SOLICITATION AMENDMENT MODIFICATION DE L'INVITATION

Title - Sujet Acq.d'un(1) Vérin Mobile à colonnes	
Solicitation No. - N° de l'invitation W0130-13GC08/A	Amendment No. - N° modif. 001
Client Reference No. - N° de référence du client W0130-13-GC08	Date 2013-12-24
GETS Reference No. - N° de référence de SEAG PW-\$MTA-215-12501	
File No. - N° de dossier MTA-3-36127 (215)	CCC No./N° CCC - FMS No./N° VME
Solicitation Closes - L'invitation prend fin at - à 02:00 PM on - le 2014-01-20	Time Zone Fuseau horaire Eastern Standard Time EST
F.O.B. - F.A.B. Plant-Usine: <input type="checkbox"/> Destination: <input checked="" type="checkbox"/> Other-Autre: <input type="checkbox"/>	
Address Enquiries to: - Adresser toutes questions à: Yee, Jenny	Buyer Id - Id de l'acheteur mta215
Telephone No. - N° de téléphone (514) 496-3870 ()	FAX No. - N° de FAX (514) 496-3822
Destination - of Goods, Services, and Construction: Destination - des biens, services et construction:

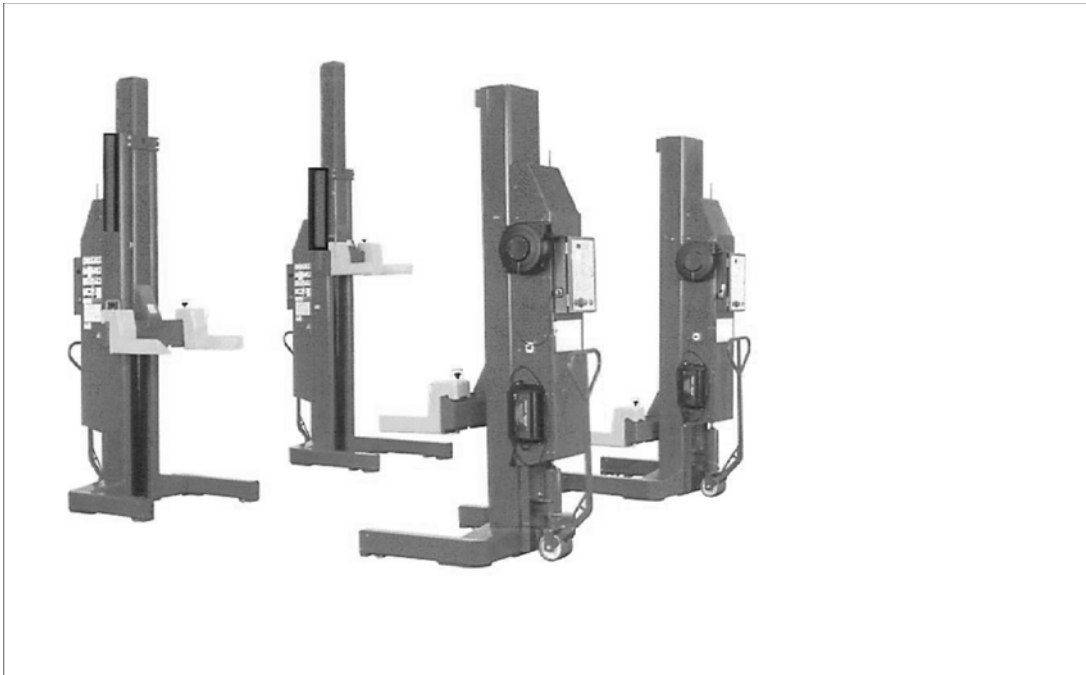
QUESTION 1:

Is there a plan or schema? If not, can we see an example of what you are looking for?

No there are no plans or schema.

Here is an example of what we are looking for, informally
